**MUNICIPAL CORPORATION,
KARACHI.**

Reference No. B. S. P. 471/40

Re: Proposed Building on Plot
No.74, S.B.4, Saddar Bazar Qr.

PLAN SHOWING PROPOSED BUILDING

SECTION ON AB.

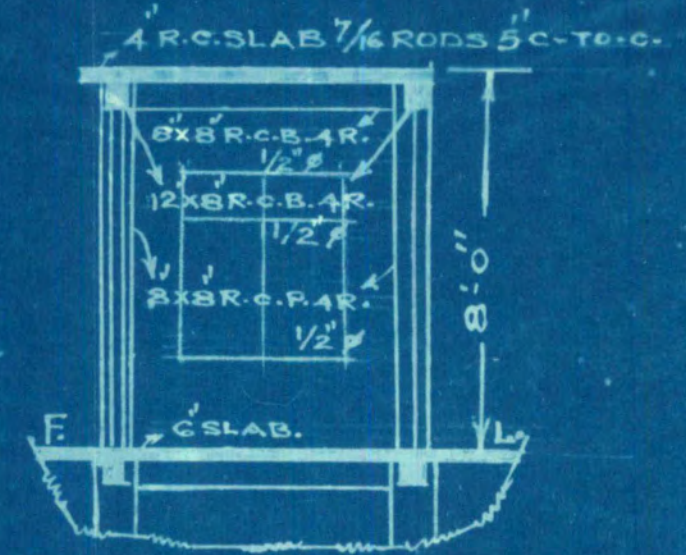
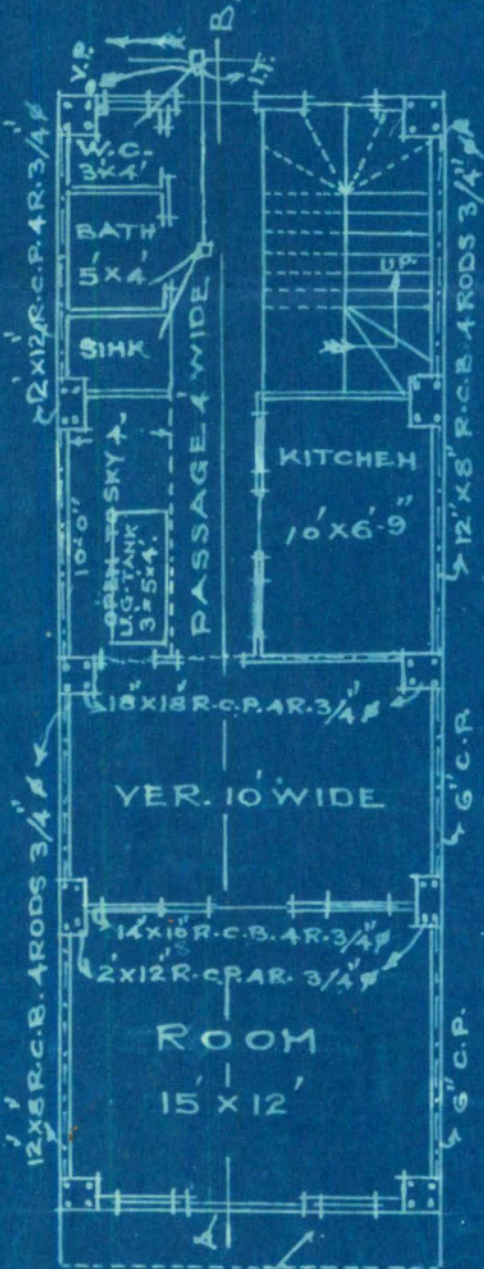
- (2) Verandahs and kitchens will be dark.
(3) Obj. 6 dated 20-10-40 stands
(4) Plinth offset on Municipal land should be removed from section

(4) As already stated in my letter dated 25th October 1940, the plinth offset shall be within the Owner's limit. However, as desired, the same has been removed from the section.

GROUND FLOOR

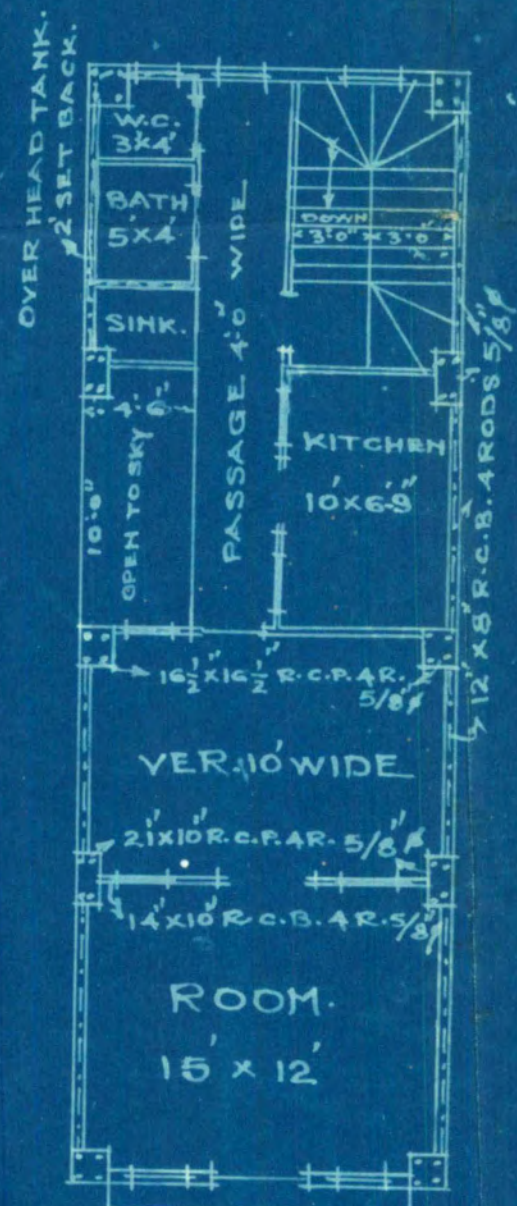
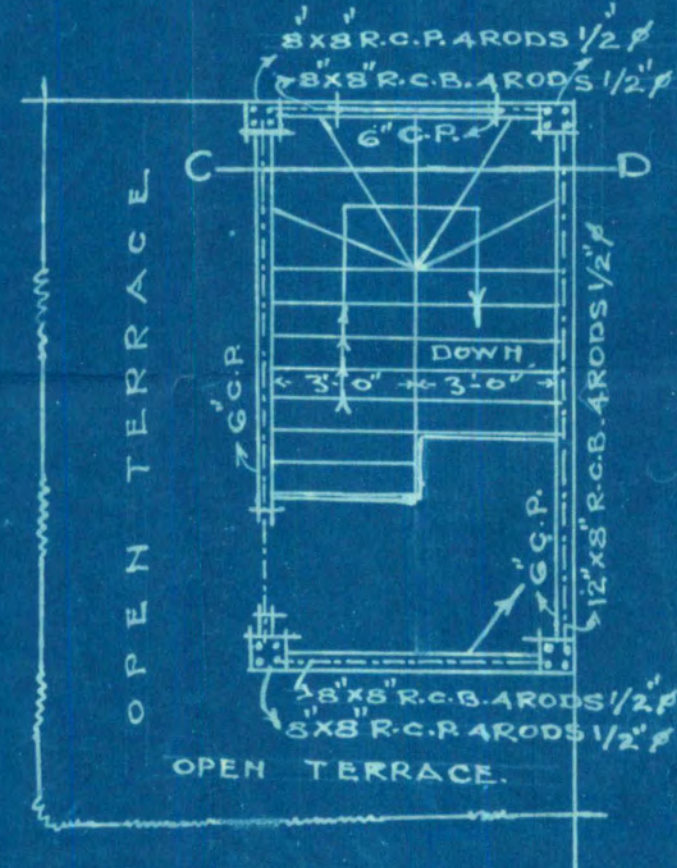
- (6) Title deed be produced.
- (7) Verandahs and kitchens will be dark.
- (8) Instead of windows to the staircase and the passage in the rear wall, jalliwork be provided.
- (9) Is there a wall separating the staircase from the sanitary conveniences? If so, its height be specified.
- (10) Plinth off-sets cannot be allowed on Municipal land.
- (11) On what does the 8"x8" pillar to the N.E. of staircase-shed rest?

(7) The Verandahs shall have ample light as portions of the same abut on the open to sky. The kitchens will also get sufficient light from the open to sky which they are directly facing.

(8) Jali work instead of windows may be provided to the staircase in the rear wall, as desired, but windows are absolutely necessary and will be useful than jali work in the passages.

(9) As already shown a cement block wall

high with Jali work over it shall be provided between the staircase and the sanitary conveniences.

(11) As shown in the plans, the 8" x 8" pillars to the N.E. of the staircase covering shall rest on the R.C.C. beam between the Kitchen and the Staircase room.
